### APPEAL SUMMARY

<b>Appeal ID:</b> 27742	<b>Project Address:</b> 3251 SW Sam Jackson Park Rd
<b>Hearing Date:</b> 5/11/22	<b>Appellant Name:</b> Marcus Morgan
<b>Case No.:</b> E-001	<b>Appellant Phone:</b> 503-816-4438
<b>Appeal Type:</b> Electrical	<b>Plans Examiner/Inspector:</b> Carl Ebbert, Brian Crise
<b>Project Type:</b> commercial	<b>Stories:</b> 15 <b>Occupancy:</b> I-2 <b>Construction Type:</b> I-A
<b>Building/Business Name:</b> Hatfield Research Center <b>Fire Sprinklers:</b> Yes - Fully Sprinklered	
<b>Appeal Involves:</b> Alteration of an existing structure <b>LUR or Permit Application No.:</b> 22-126563-ET	
<b>Plan Submitted Option:</b> pdf [File 1]	<b>Proposed use:</b> Hospital

#### Appeal item 1

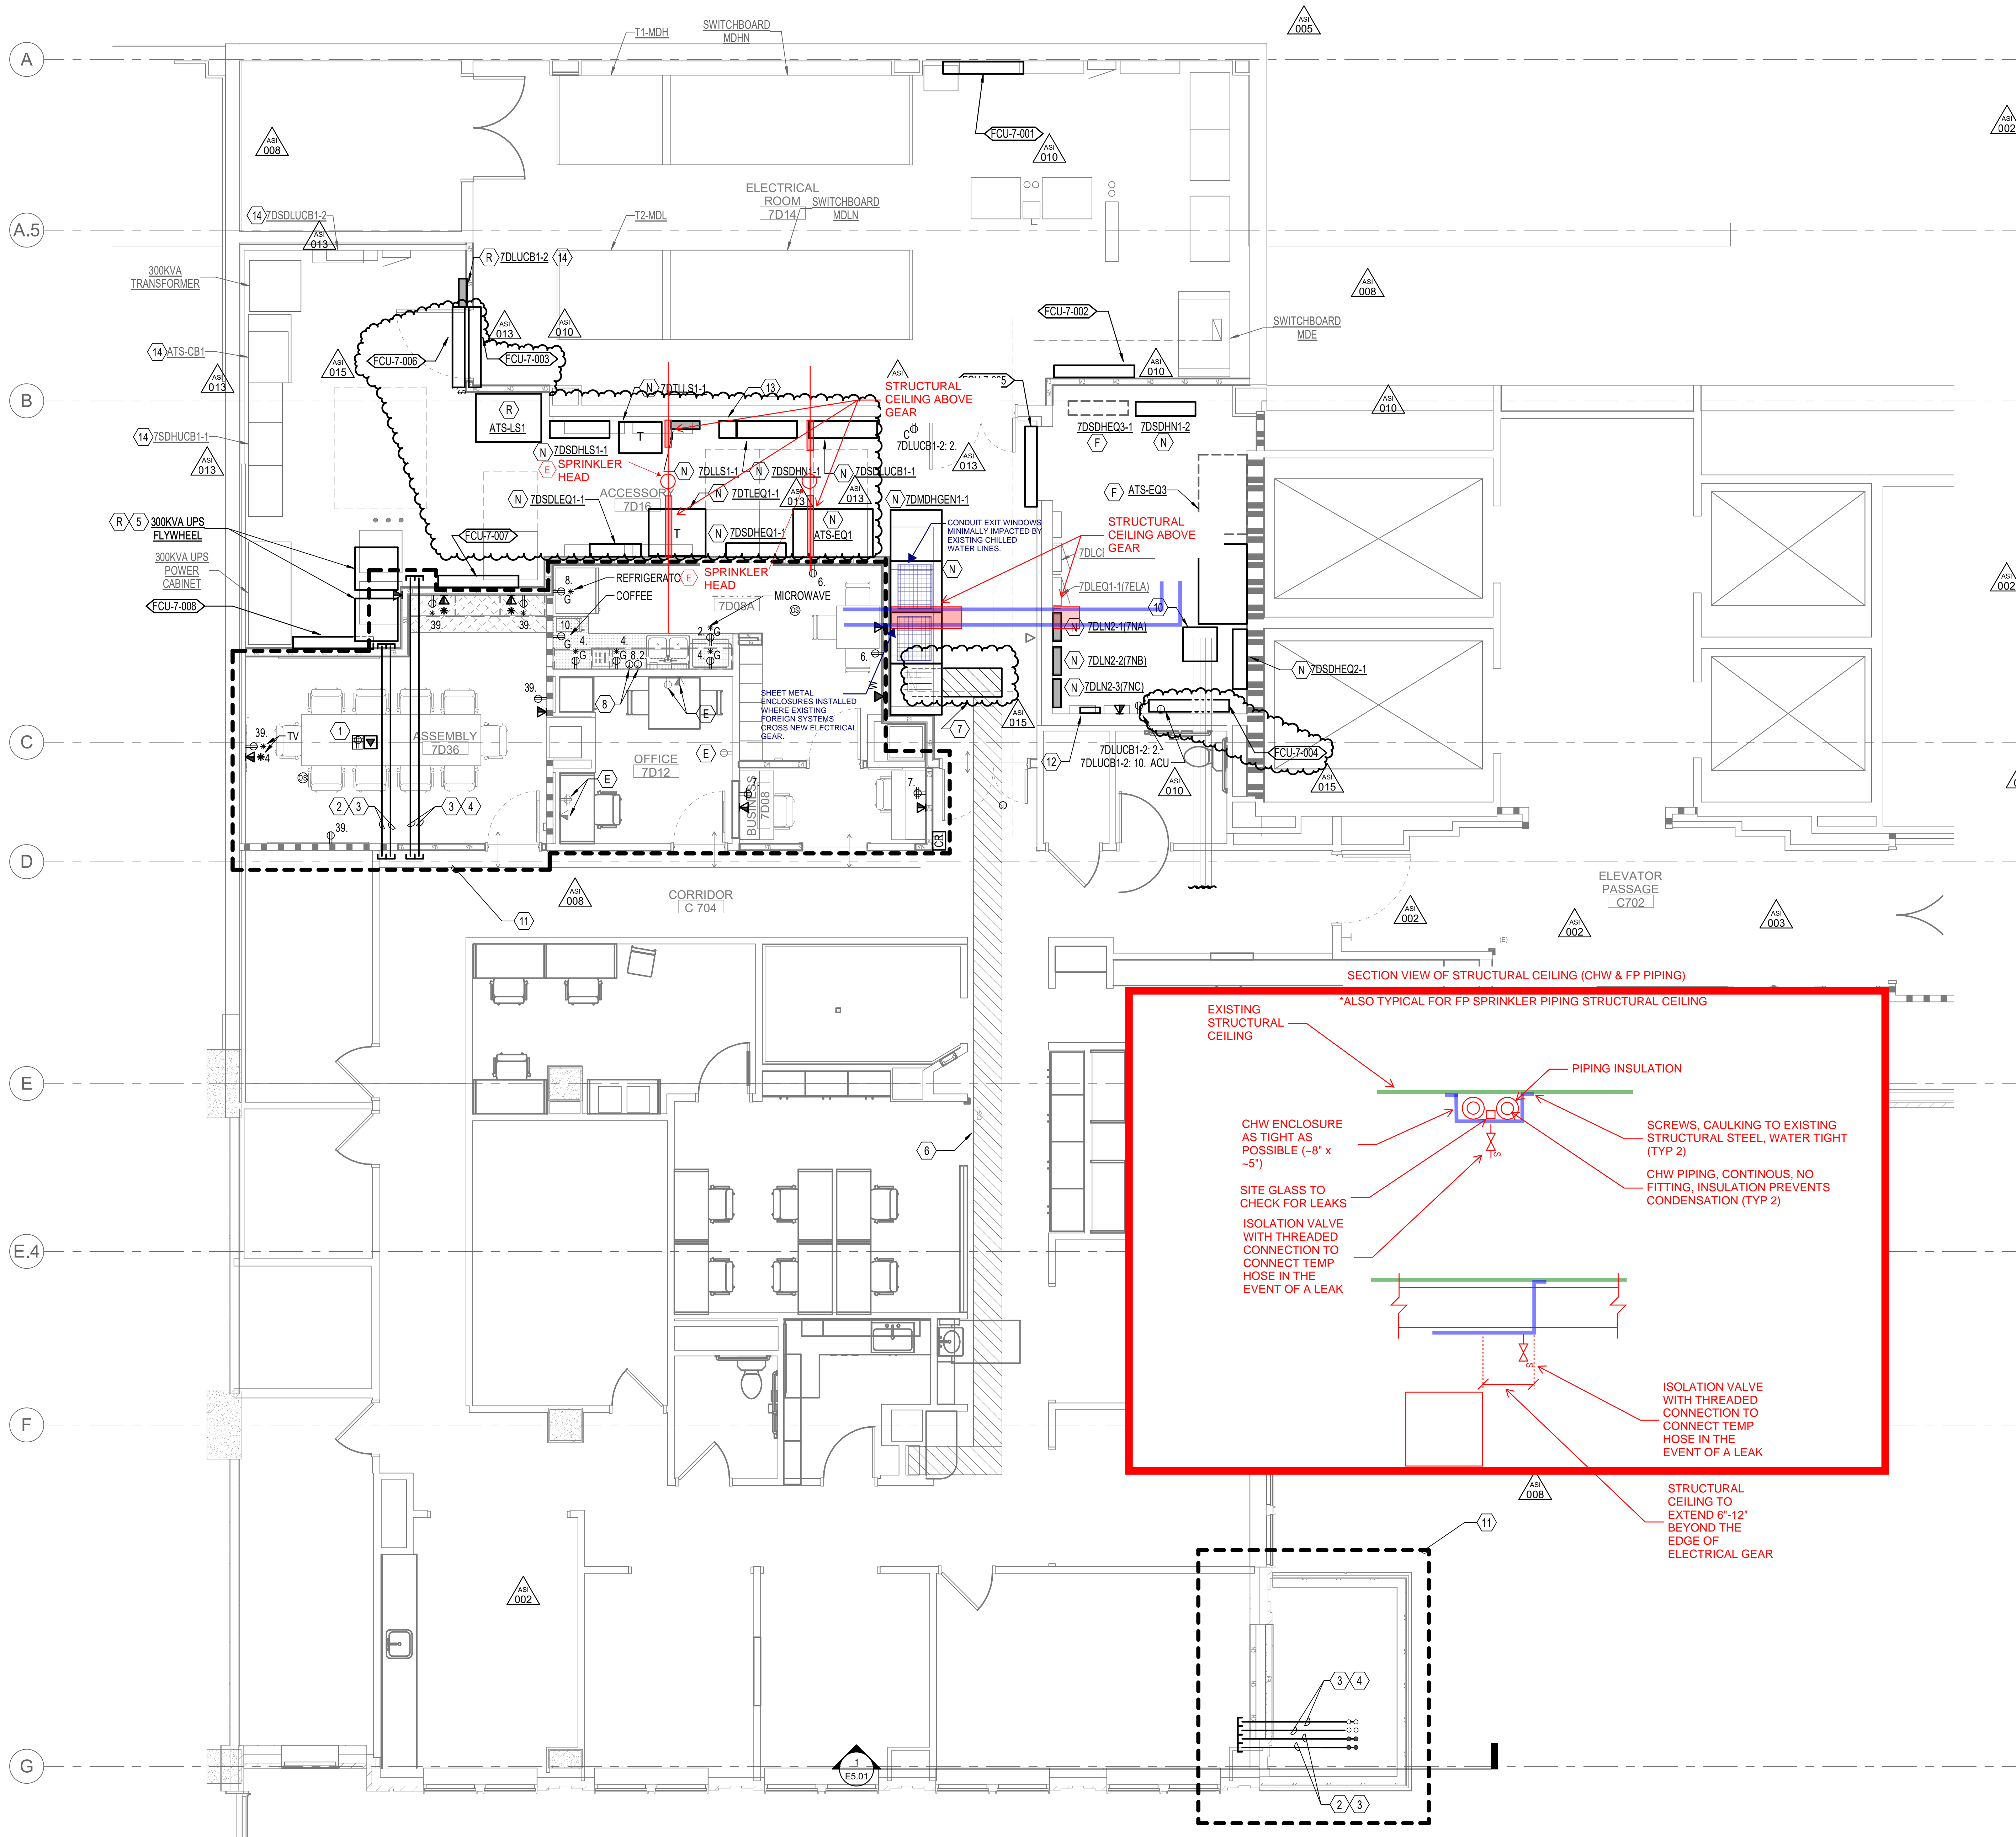
<b>Code Modification or Alternate Requested</b>	Existing piping will remain in place per OSMC 102.5 and 102.6. Structural sheet metal enclosures will be installed tight to structure, and it will enclose the existing HVAC and fire protection piping sections located directly above the electrical gear.
---	--

<b>Proposed Design</b>	<p>The new electrical room is cooled by a number of new chilled water fan coil units. All new chilled water piping and condensate piping is not routed above the electrical gear, and as such is in compliance with the above listed code sections.</p> <p>The existing chilled water pipes cross over emergency electrical switchgear to serve the new chilled water piping. As stated above, new chilled water piping is routed around all other electrical gear (not crossing over gear).</p> <p>The existing fire protection water pipes were left in place but cross over electrical gear. The fire protection pipes serve the electrical rooms and provide full coverage as required by NFPA 13.</p> <p>Existing piping will remain in place per OSMC 102.5 and 102.6. Structural sheet metal enclosures will be installed tight to structure, and it will enclose the existing HVAC and fire protection piping sections located directly above the electrical gear. The sheet metal enclosures will be sealed watertight. A site glass will be provided to check for leaks and a drainpipe with isolation valve and threaded connection for a temporary hose in the event of a leak.</p> <p>In addition to sheet metal enclosures, chilled water piping will be pressure tested. Continuous insulation with vapor barrier will be applied to chilled water pipes. As designed and installed, the piping system will prevent damage to newly installed electrical gear. The installation of sheet metal enclosures will leave plenty of room to run any future conduits.</p>

<b>Reason for alternative</b>	<p>OHSU has extensive existing systems, and space for new utilities is extremely limited. Rerouting existing utilities that serve the intended installation space is not feasible due to the congestion of existing utilities in the area and the critical nature of the medical and research facilities that they serve. Design team believes the proposed installation meets the intent of the code to prevent water damage and allow for conduit entry and exit from the switchboard.</p> <p>Existing chilled water piping is not impeding space to service the equipment or for future conduit installation. To prevent water damage the chilled water piping is soldered or brazed and is effectively a continuous system. No screwed fittings, press fittings, or other similar fittings are allowed. Piping is tested at 150PSI to confirm the system is leak free before operation; this test pressure is approximately four times higher than the normal operating pressure of chilled water system. The chilled water piping is insulated and provided with a vapor barrier to prevent condensation. In addition, sheet metal enclosures will be installed as secondary protection to the new electrical equipment (please refer to included sketches).</p> <p>All new chilled water piping and condensate piping is not routed above the electrical gear. New fan coil units will have condensate pipes routed to floor drains. All condensate piping is soldered copper and is a continuous system. No screwed fitting, press fittings, or other similar fittings are allowed. Condensate piping will not be routed above any electrical equipment. Piping will be tested to 150PSI to confirm the system is leak free before operation (condensate has no operating pressure).</p> <p>Fire sprinkler piping only serves the space and is required to provide coverage per NFPA 13. A structural sheet metal enclosure will be installed in any location where the existing piping crosses above the new electrical gear (please refer to included sketches).</p>

**Existing piping to remain within electrical room: Granted as proposed.**
